SOUTH BUILDING ELEVATION | 1

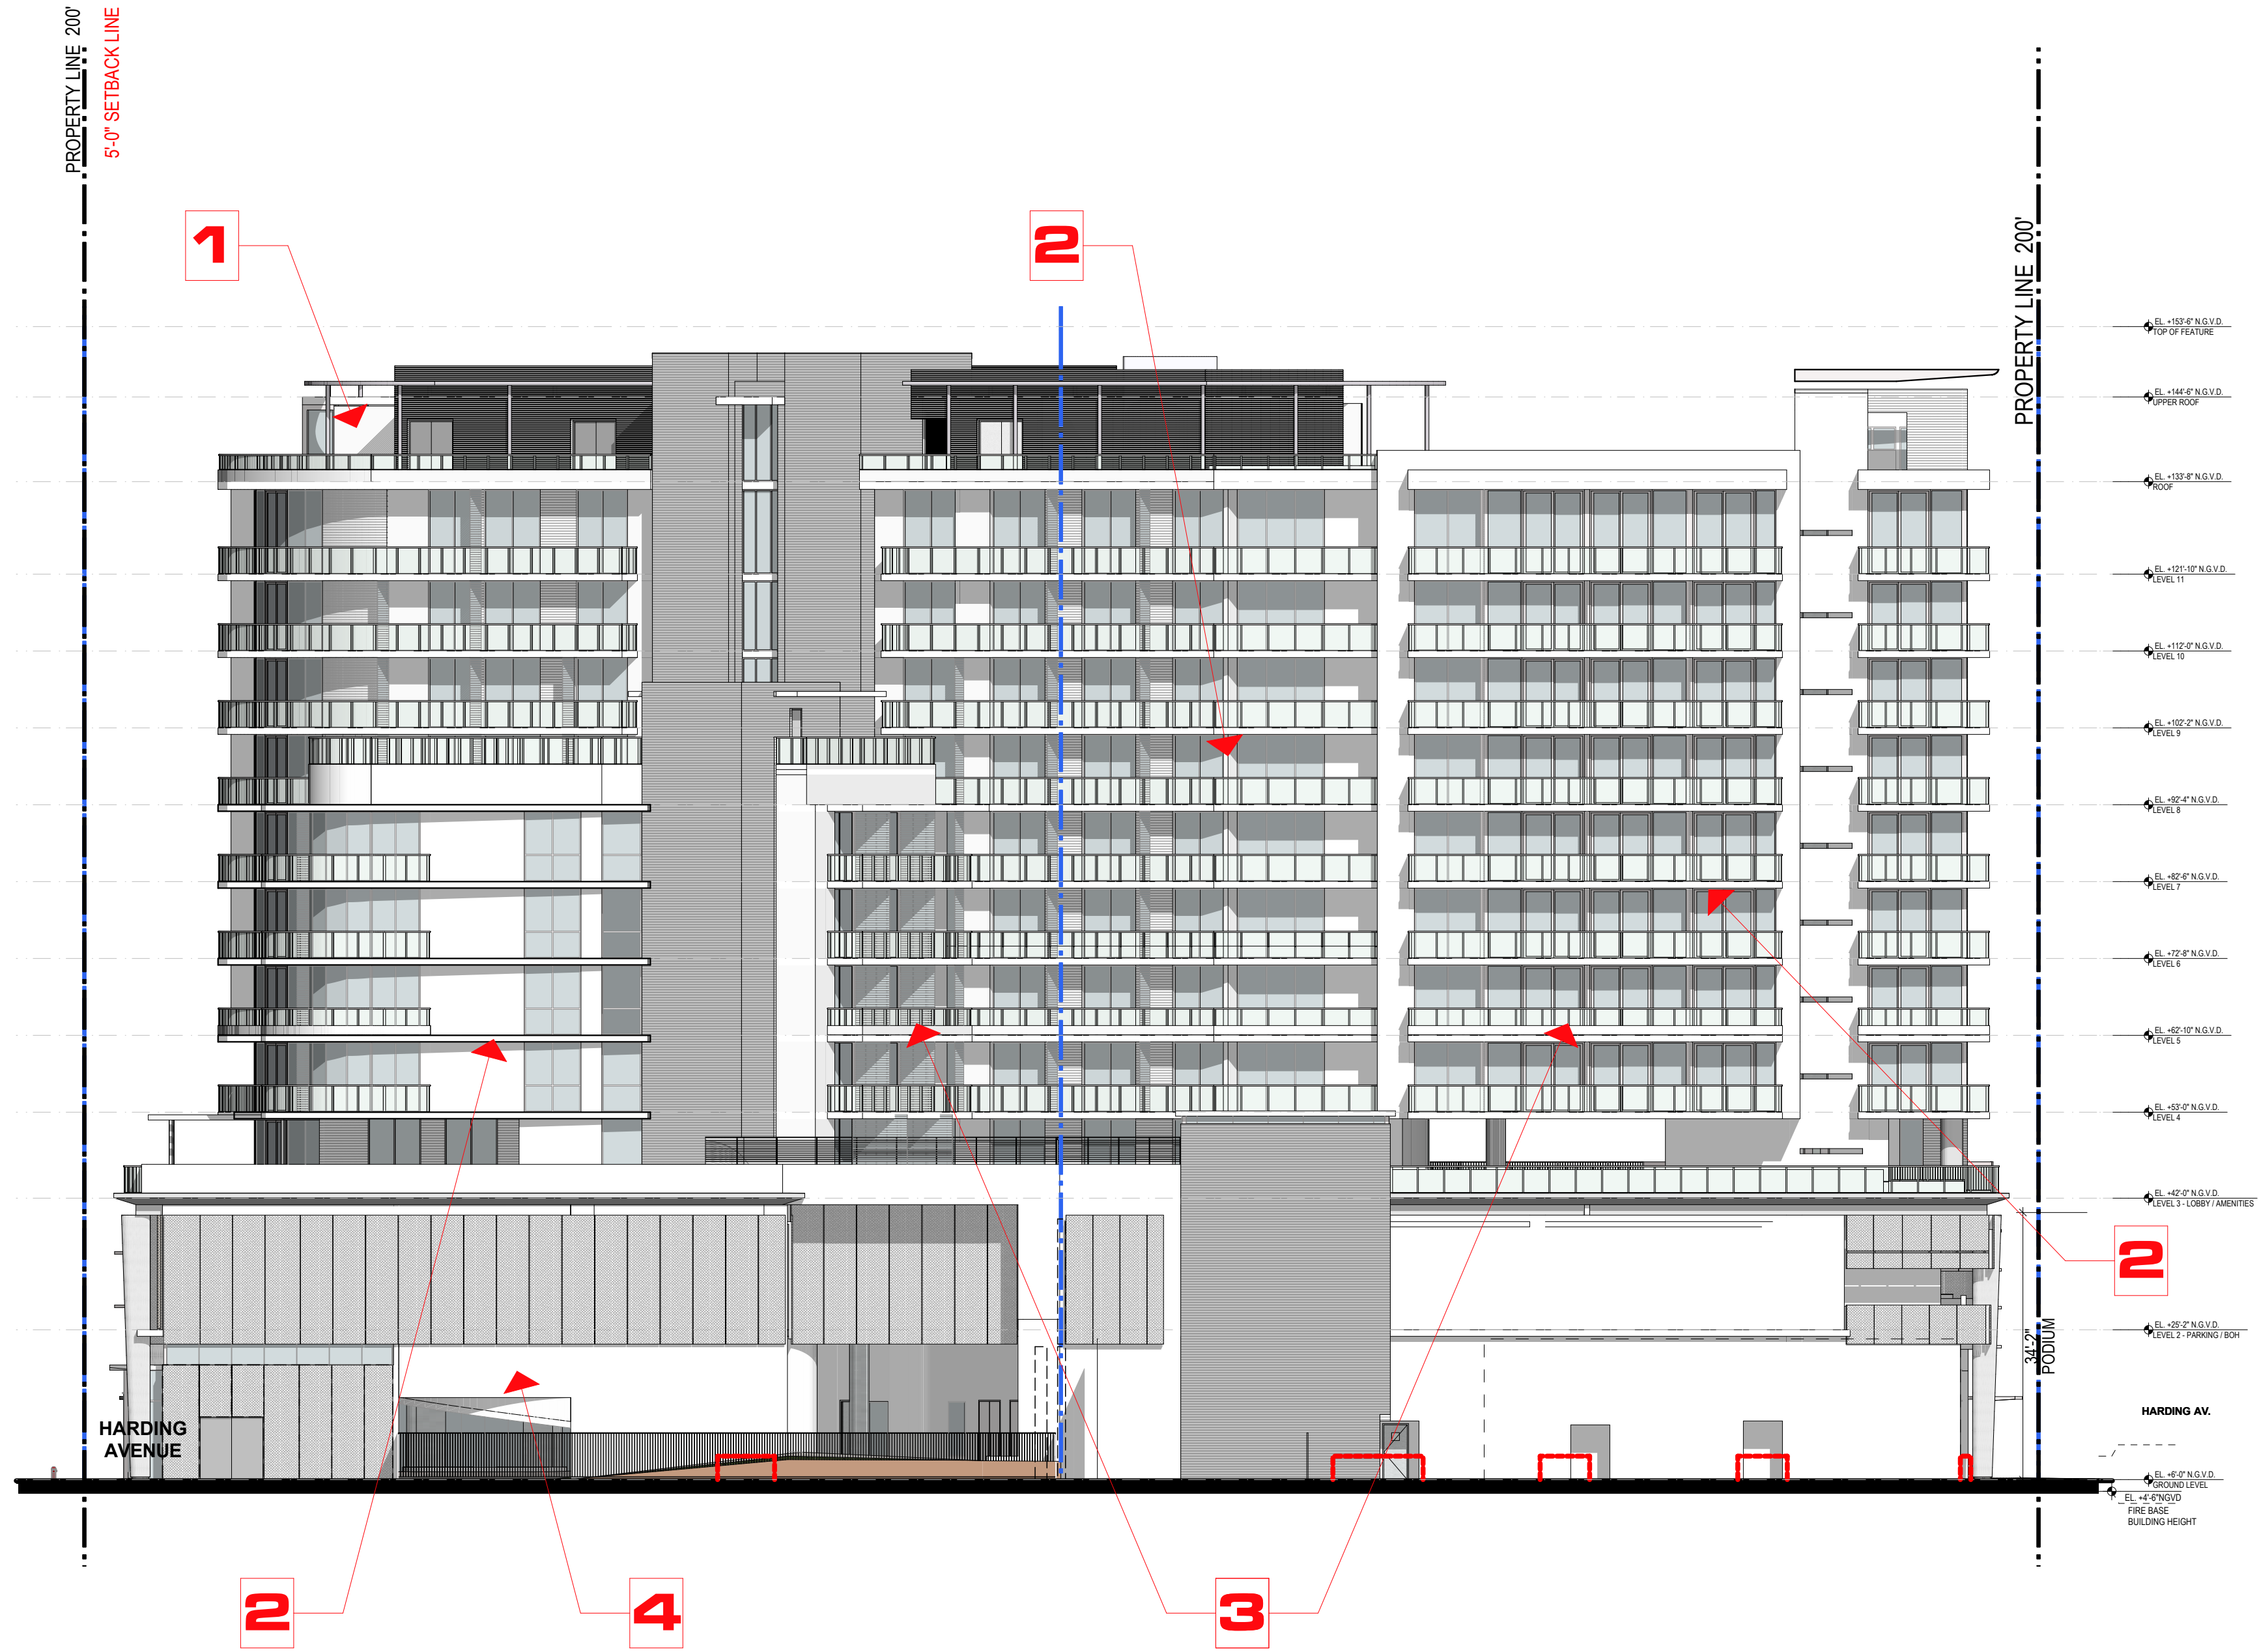
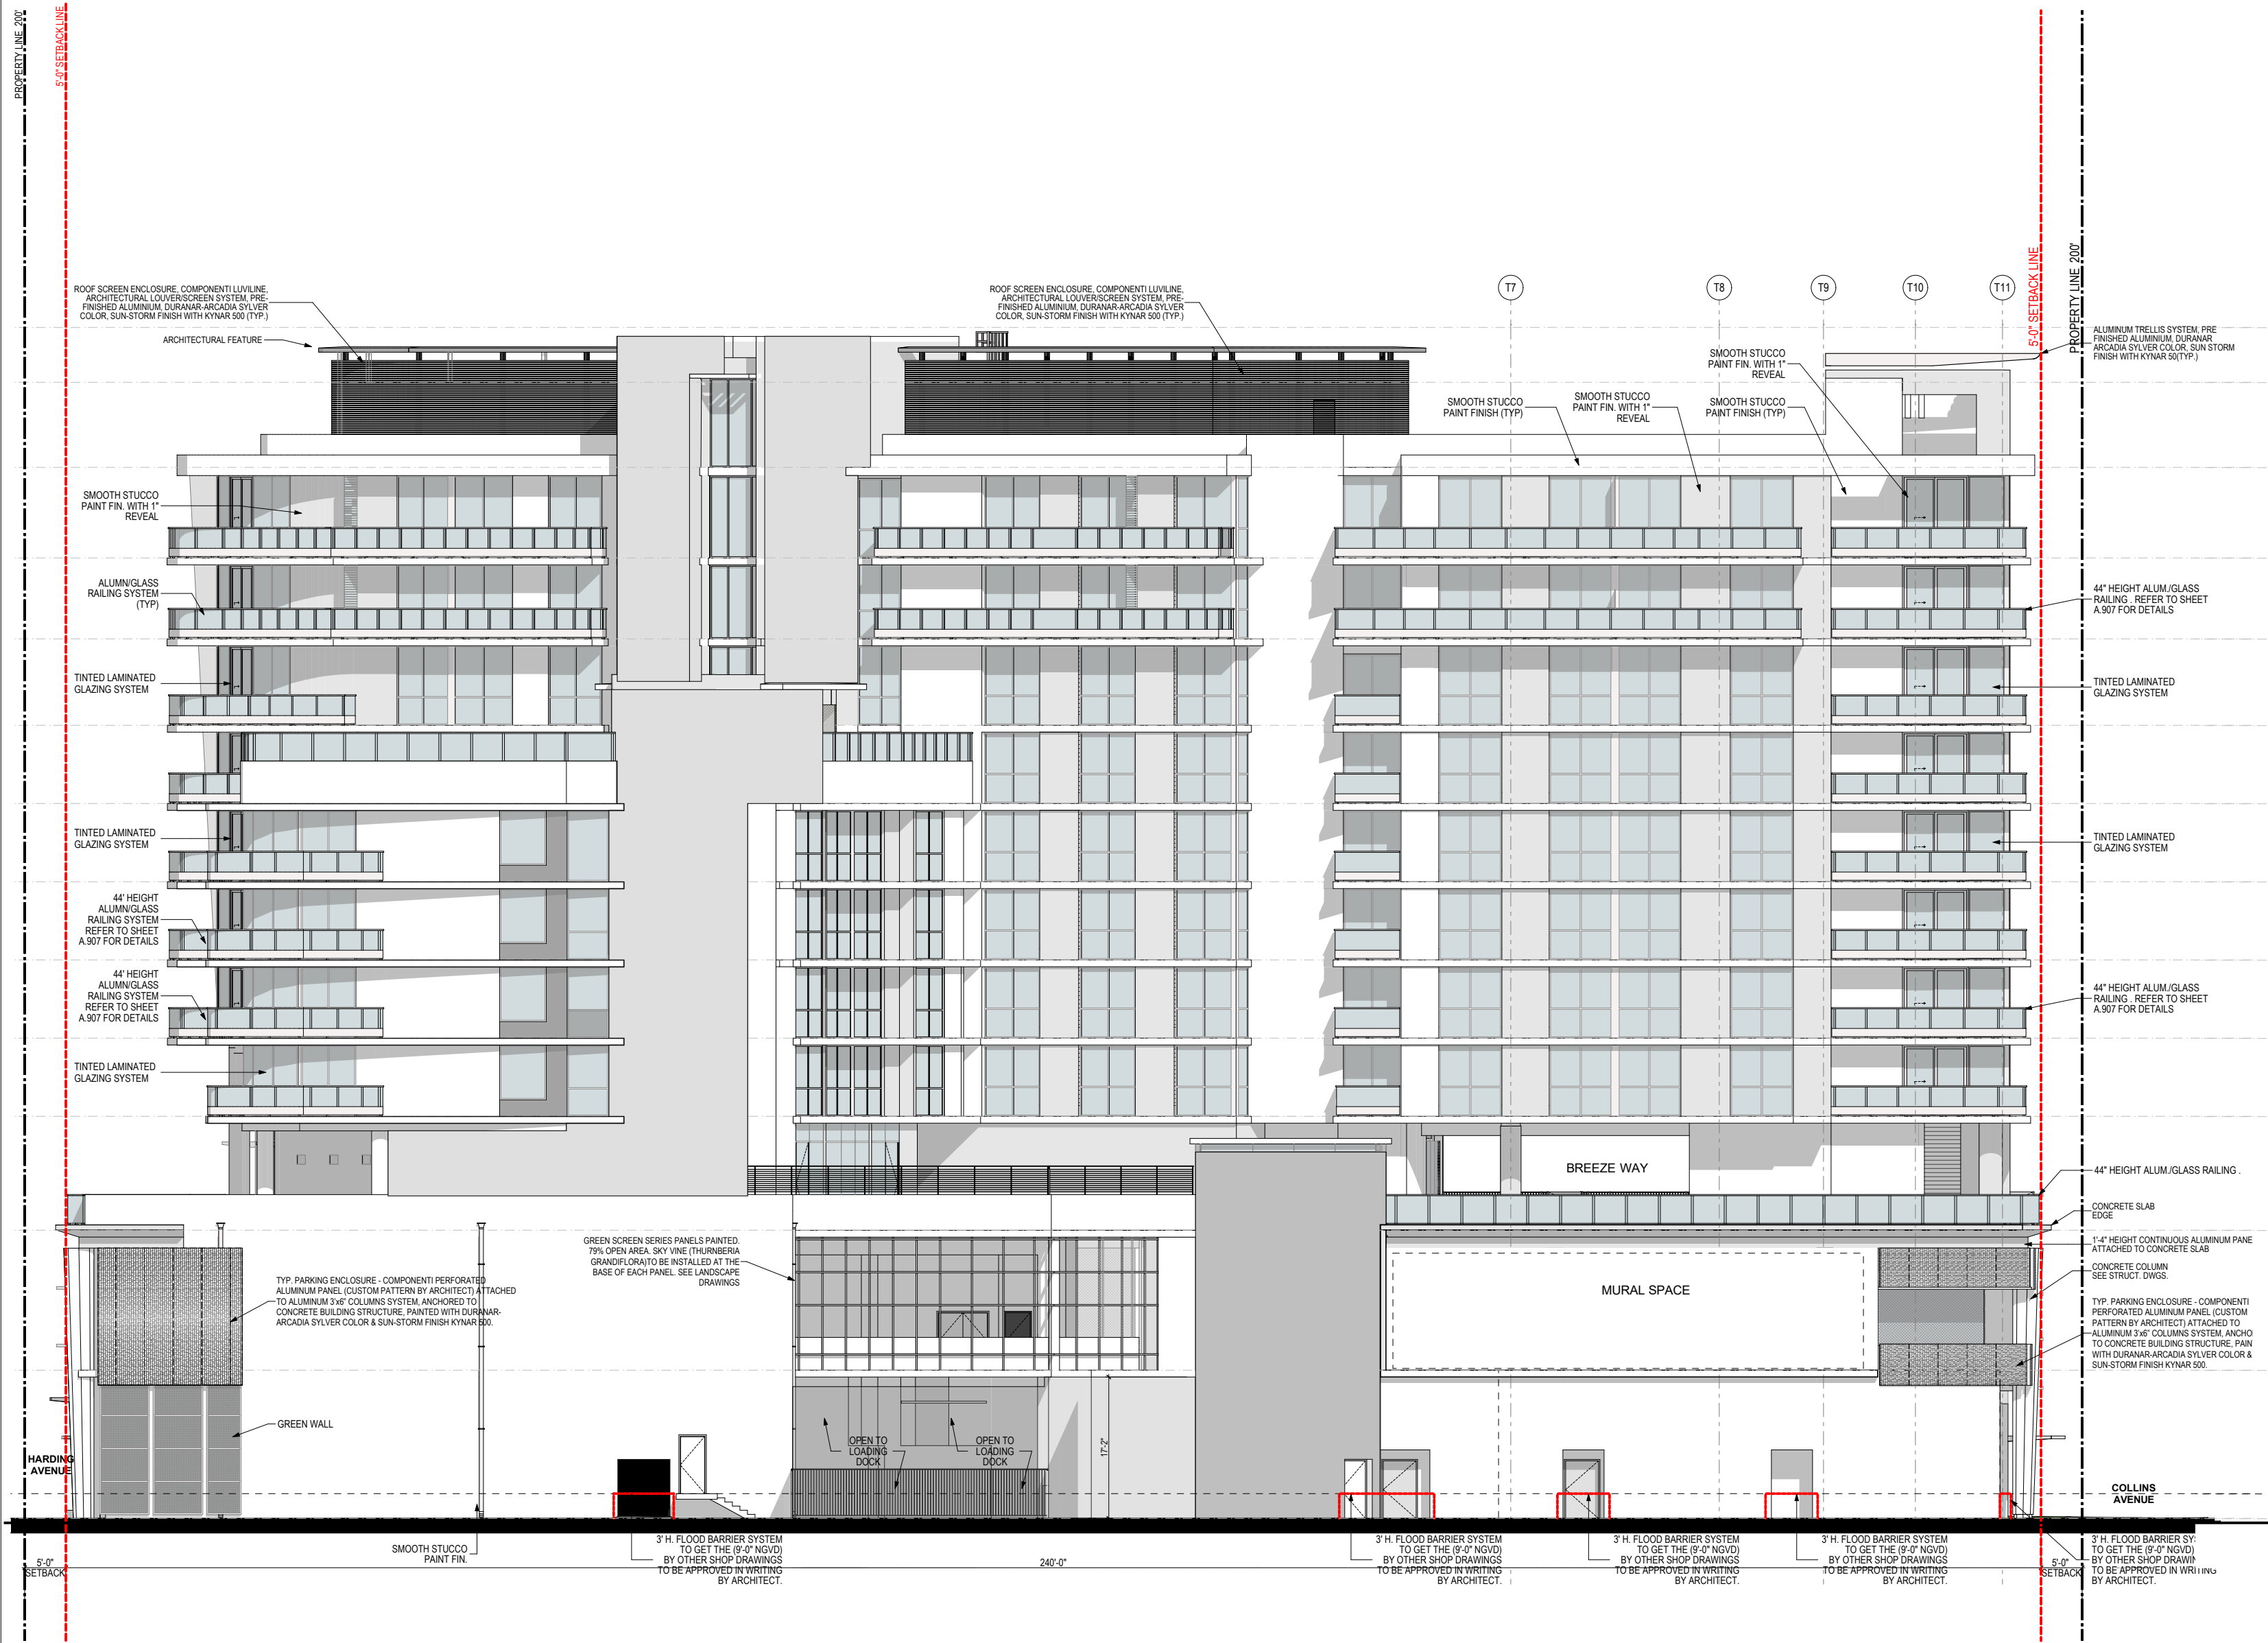
1. PROPOSED NEW ROOF-TOP
2. INTERIOR ORGANIZATION TO ACCOMMODATE CO-LIVING UNITS
3. REPLACING OF PREVIOUSLY APPROVED EYEBROWS BY BALCONIES AT NEW CO-LIVING UNITS
4. REPLACEMENT OF CAR ELEVATORS BY A REGULAR RAMP
